MCPB
Item # A and B
November 12, 2009

MEMORANDUM

SUBJECT: Staff Recommendations for Planning Board approvals of:
A. **Special Protection Area (SPA) Preliminary/Final Water Quality Plan, and**
B. **Preliminary Forest Conservation Plan associated with Mandatory Referral No. 09707-MCPS-01, Fairland Elementary School**

Impervious Area Mitigation Plan for
Cloverly Elementary School

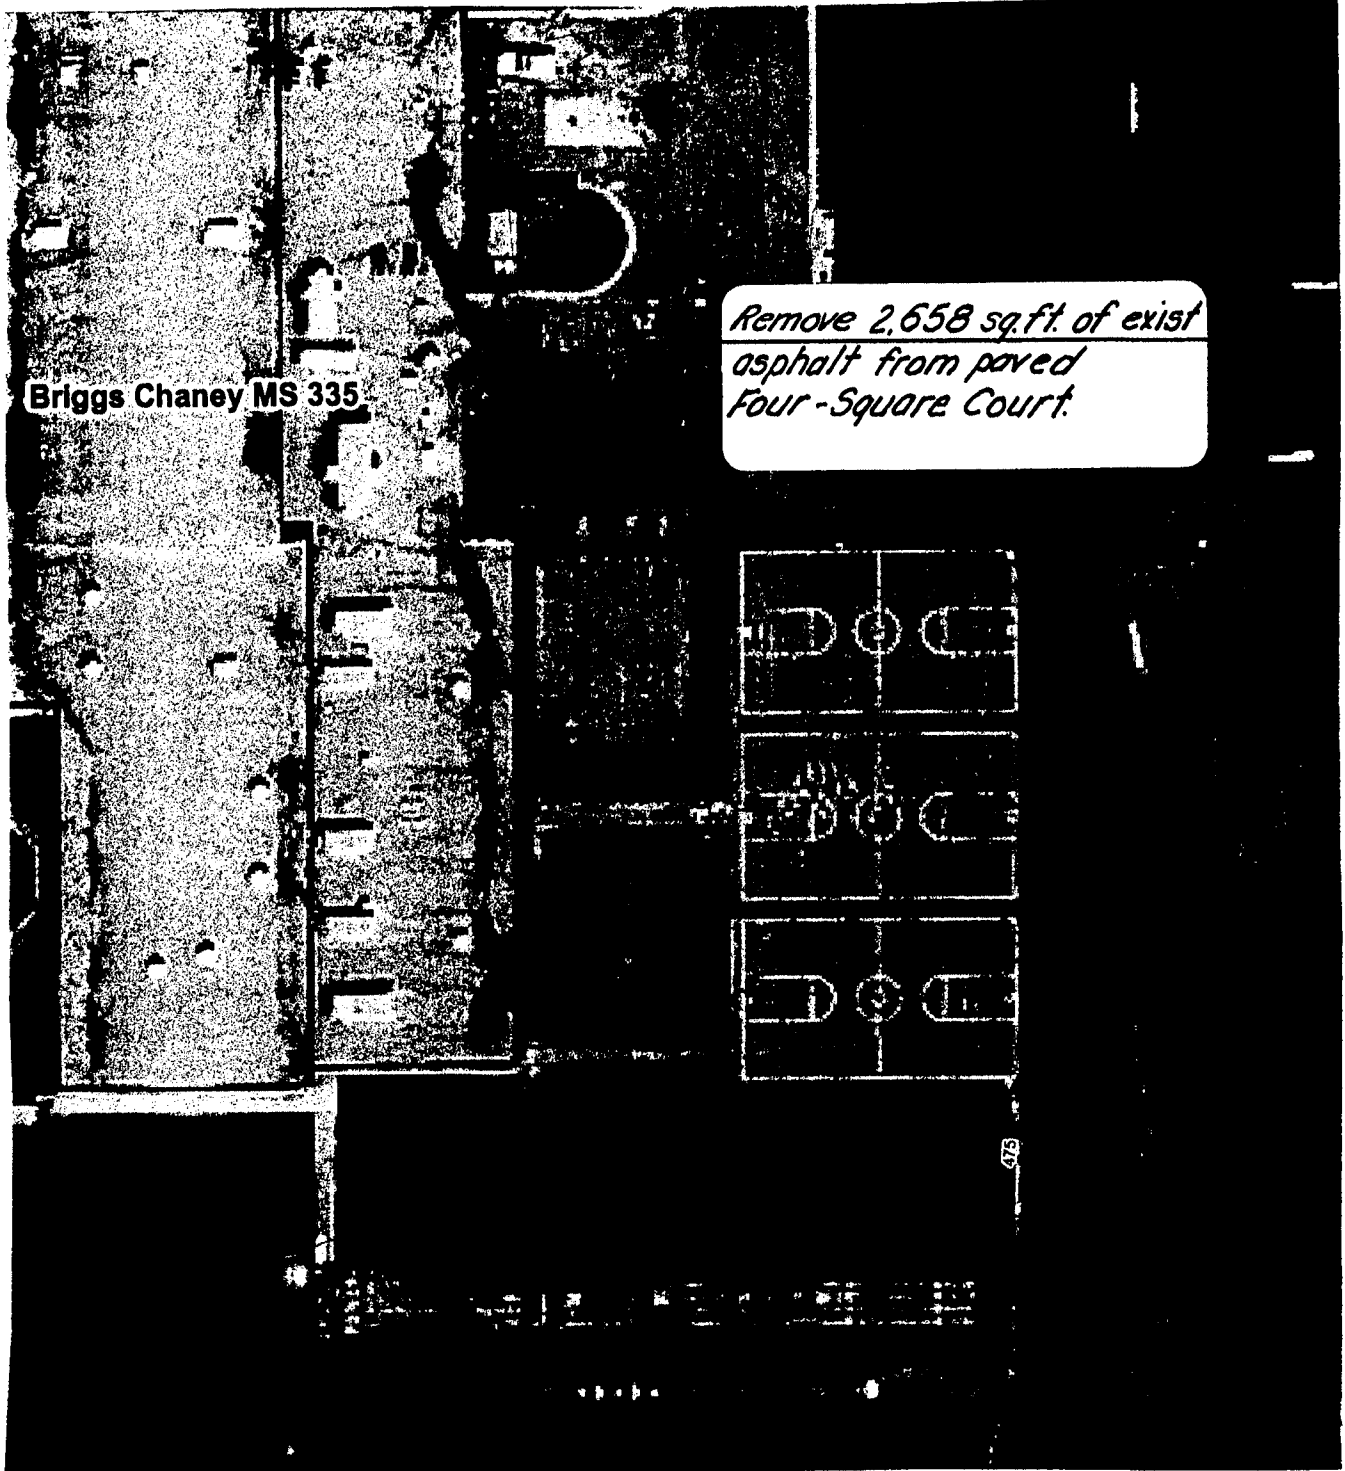
Pursuant to the Planning Board's November 8, 2007 approval of the Cloverly Elementary School gymnasium addition and in satisfaction of comment 1.a on page 2 of your letter of November 26, 2007, Montgomery County Public Schools will remove 2,658 square feet of asphalt pavement at the Briggs Chaney Middle School. The area being removed is currently used as a paved play area. Both Cloverly Elementary School and Briggs Chaney Middle School reside in the Upper Paint Branch Special Protection Area of Montgomery County, and the removal of the 2,658 square feet of asphalt from the Briggs Chaney Middle School will offset the excess impervious area at the Cloverly Elementary School.

Enclosed is an aerial photograph of the Briggs Chaney Middle School site showing the location of the 2,658 square feet paved play area to be removed.
